U.S. Department of Energy

MAR 26 2003

Subject: Request to Remove the Strangford Road Access Gate and Sign at the Burrell,
Pennsylvania, Disposal Site - WM-42

9/2002. Photo 1. East gatepost of access gate at Strangford Road, Burrell, Pennsylvania, disposal site.

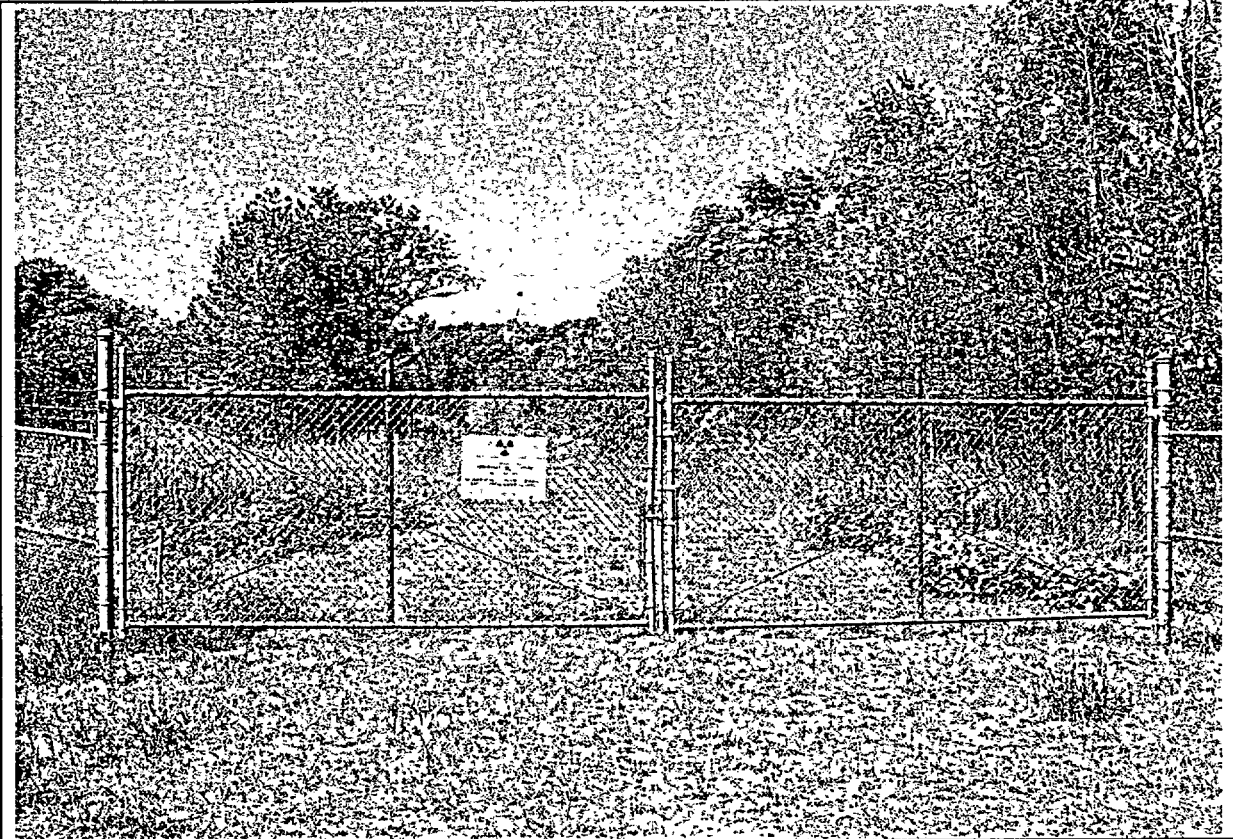
During the 2002 annual inspection of the Burrell, Pennsylvania, disposal site, the access gate at Strangford Road was found to be in disrepair, as shown on the enclosed Photos 1 and 2. The presence of a gate at that location does not add to site protectiveness or security, and creates an unnecessary maintenance obligation. Therefore, the Department of Energy Grand Junction Office (DOE-GJO) requests a change in the site long-term surveillance plan (LTSP) regarding removal of the gate and its entrance sign.

The double-swing chain link gate is 6 feet tall and has a typical entrance sign mounted to it. It is located at the beginning of the perpetual easement leading to the disposal site. The DOE allowed the railroad to install a padlock in series with the Long-Term Surveillance and Maintenance Program lock to provide access to their right-of-way. Since that was done, however, the lock and chain have been repeatedly missing during site visits. Two gas wells were installed, since the completion of the disposal site, and are also accessed by others through this gate.
